Application no: 22/03078/FUL

Location: Land Bounded by Meadow Lane and Church Way, Iffley, Oxford

Construction Traffic Impact Assessment

Figure 6: Five-day average flow Profile – Meadows Lane

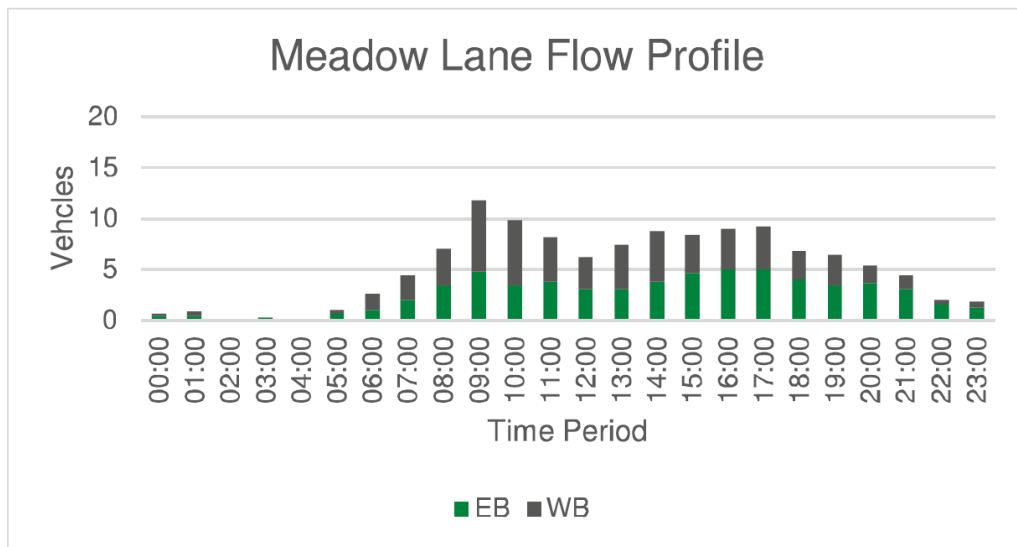
- 7.1 The applicant's Traffic Statement solely analyses traffic movements generated by the completed development. The conclusions are detailed in the tables below.
- 7.2 The Meadow Lane Flow profile indicates a vehicle trip generation of 12 movements between 08.00 and 09.00 which will be the time for peak construction vehicle movements.
- 7.3 Our analysis above shows construction movements during this period will be generally c.2.5x higher (32), with a peak significantly higher and this is exclusive of delivery vehicles entering the site at this time.

- 7.4** Afternoon peak construction vehicle movements are between 15.30 and 16.30 and our analysis above shows these movements to also be generally 32. By contrast, the applicant's assessment of Meadow Lane flow profile shows the completed development generates 7-8 movements in this time window.

- 7.5** So during the 15 month construction period traffic flows on the Iffley road network will be between 3-5 times greater than that generated by the completed development.
